UNITED STATES NUCLEAR REGULATORY COMMISSION

AMENDMENT TO
APPLICATION FOR AMENDMENT
OF
FACILITY OPERATING LICENSES
DPR-44 & DPR-56

PEACH BOTTOM ATOMIC POWER STATION - UNITS 2 AND 3

FIGURE 6.2-1

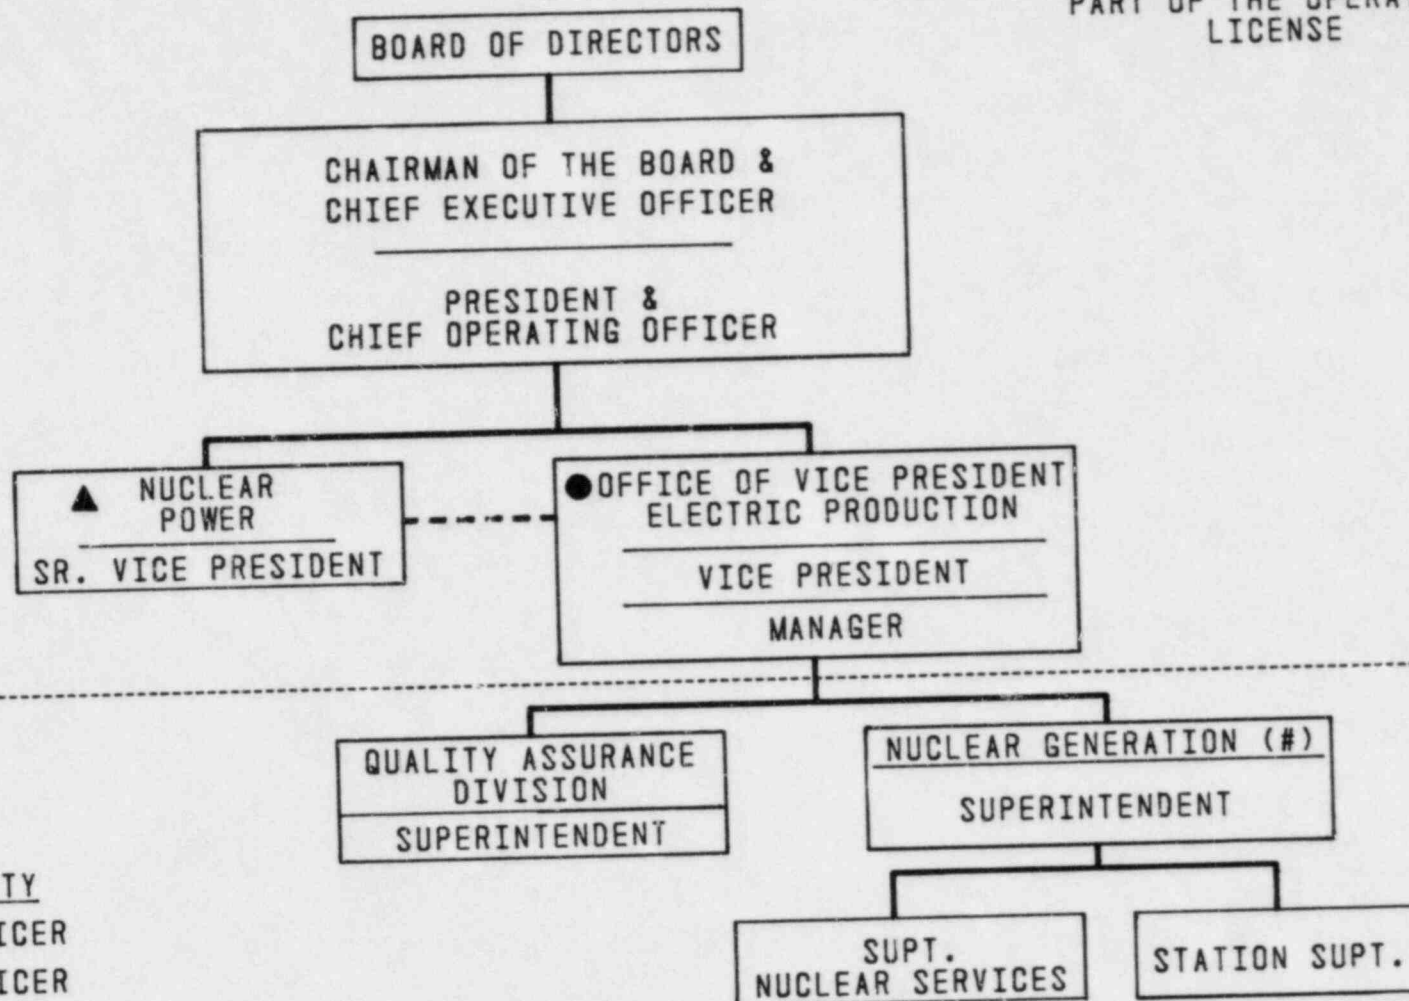
As a result of recent organizational changes including splitting of the Generation Division into separate Fossil/Hydro

and Nuclear groups, and the formation of a Nuclear Services group (the Superintendent of which serves as an alternate to the Superintendent of Nuclear Generation) Licensee hereby revises its Application of May 23, 1980, as revised August 1, 1980 and June 2, 1981, by:

- a) deleting from the application proposed Figure 6.2-1 of Appendix A to the Operating Licenses and substituting therefor the proposed revised Figure 6.2-1 which is attached hereto and incorporated herein by reference; and
- b) deleting from the Application proposed Figure 7.1-1 of Appendix B to the Operating Licenses and substituting therefor the proposed revised Figure 7.1-1.
